Model: PRIPORT LCS	Date: 7-Jan-04	No: R-C625-001c
Subject: Firmware Modification History	Prepared by: K. Yamamoto, Priport Service Planning Section	
Classification: <input type="checkbox"/> Troubleshooting <input type="checkbox"/> Part information <input type="checkbox"/> Action required <input type="checkbox"/> Mechanical <input type="checkbox"/> Electrical <input type="checkbox"/> Service manual revision <input type="checkbox"/> Paper path <input type="checkbox"/> Transmit/receive <input type="checkbox"/> Retrofit information <input checked="" type="checkbox"/> Other (Firmware release)		
Model Name: Large Capacity System LS3000

Model: PRIPORT LCS		Date: 4-Mar-04	No: R-C625-002
Subject: Undefined paper non-feed		Prepared by: K. Yamamoto, Priport Service Planning Section	
Classification:	<input type="checkbox"/> Troubleshooting	<input type="checkbox"/> Part information	<input checked="" type="checkbox"/> Action required
	<input type="checkbox"/> Mechanical	<input checked="" type="checkbox"/> Electrical	<input type="checkbox"/> Service manual revision
	<input type="checkbox"/> Paper path	<input type="checkbox"/> Transmit/receive	<input type="checkbox"/> Retrofit information
	<input

Service Manual (machine code: C625), pp. 3-21, 3-22

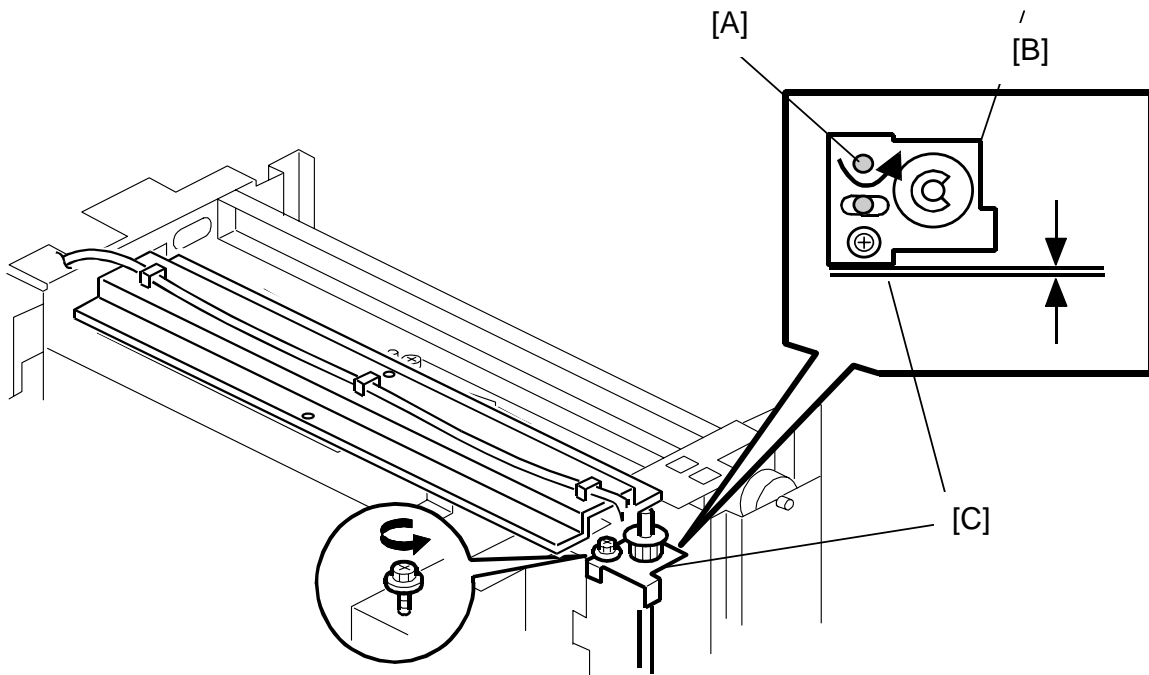
Before revision:

Note: 1) Adjust the belt tension with bracket [E]. The gap [F] must be more than 1.5 mm.

After revision:

Note: The top opening [A] in the bracket [B] is used as a pivot point to rotate the bracket and adjust the tension of the side fence belt. The bracket should be aligned parallel with the side fence [C], which will ensure the proper belt tension.

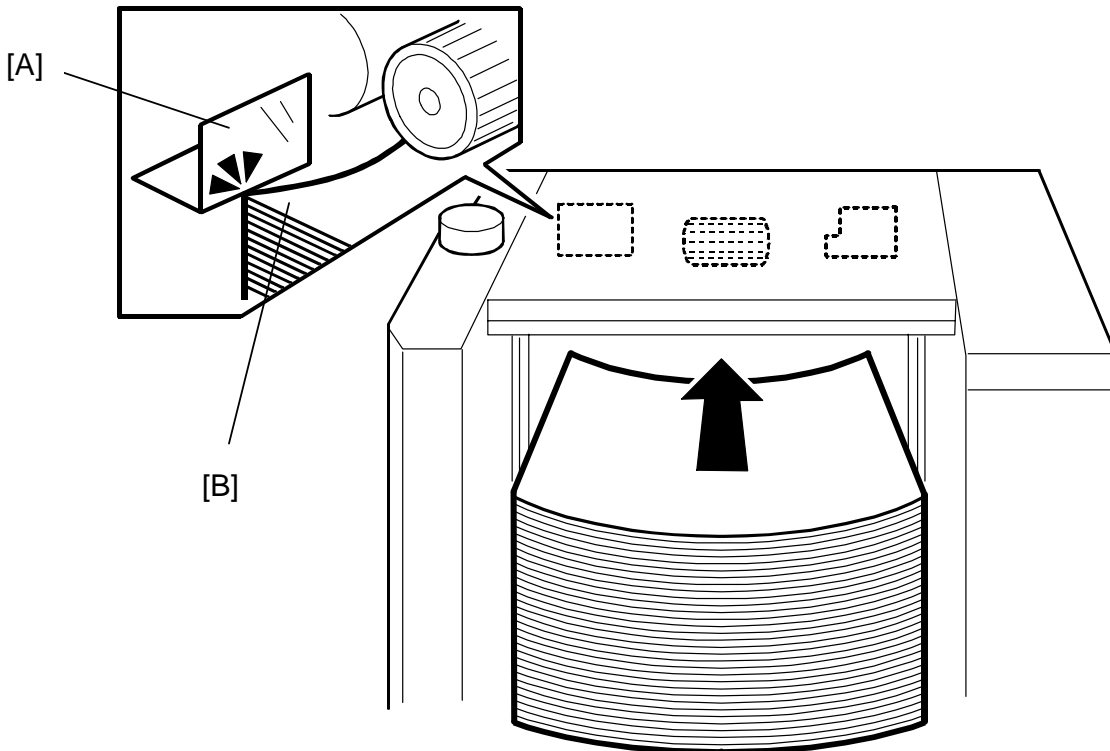
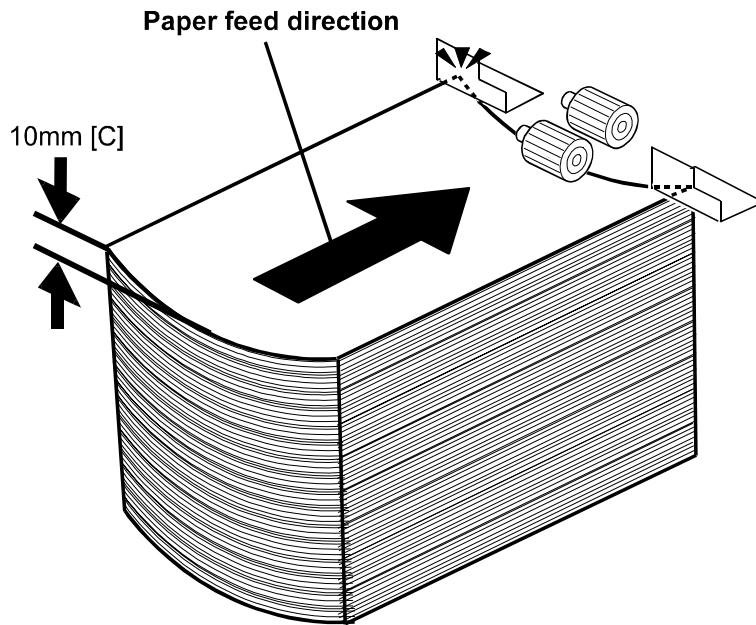
An A-jam occurs at the paper feed section if the paper is stacked near capacity (approximately 3,000 sheets) and the sheets are curled.

The paper [B] contacts the guide board sheet [A] due to the height of the stack and the curl in the paper, and the paper is fed skewed. (This curl is exaggerated with increased paper stack height).

- The curl in each individual sheet is amplified as the height of the stack increases.
- With close to 3,000 sheets, a sheet gap of about 10 mm [C] can result, which tends to trigger the skewed feed and paper jam.

The shape of the guide board sheet has been changed to improve paper feed even when the sheets are already curled and are stacked near paper feed table capacity.

- This modification ensures proper paper feed even when the sheet gap [C] is higher than 10mm (i.e. up to approximately 15mm).
- New guide board sheet P/N: C6252921 (see MB #MC625006).

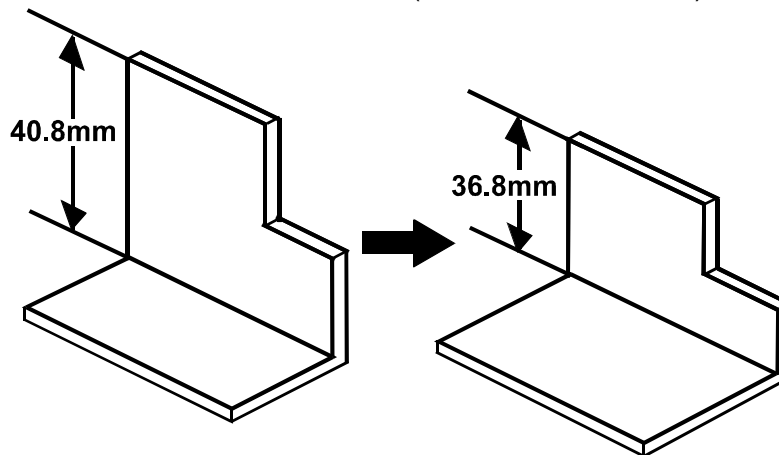
Please advise customers to use paper that is not curled, as described in the Operator's Instructions. To offset the effect from curling, it is often effective to load the paper upside down in the tray and/or fan the paper before loading.

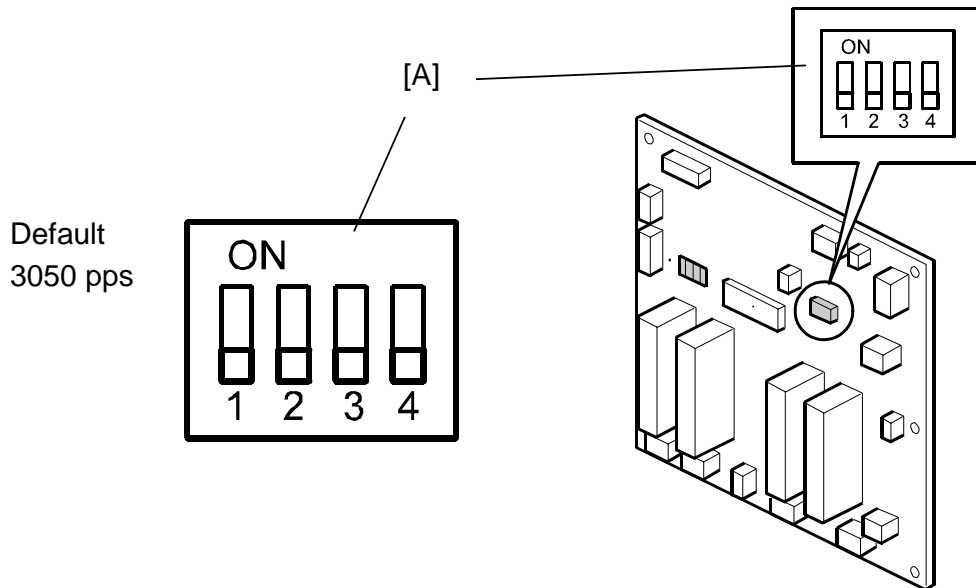
If A-jams are reported from the field, increase the paper pickup speed with the dip switch on the MPU board.

1. Turn off the main switch, and then disconnect the power plug.
2. Remove the rear cover.
3. Set the dip switch [A] on the LCIT MPU as follows.

Speed (pps)	Dip Switch			
	1	2	3	4
2550	OFF	ON	ON	OFF
2750	ON	ON	ON	OFF
3050 (default)	OFF	OFF	OFF	OFF
3200	ON	ON	OFF	OFF
3300	OFF	OFF	ON	OFF
3400	ON	OFF	ON	OFF
3500	OFF	ON	OFF	OFF

NOTE: If A-jams still occur after you increase the speed to 3500 pps, replace the paper feed roller for the LCIT. If this is not effective enough, replace the intermediate under feed rollers.
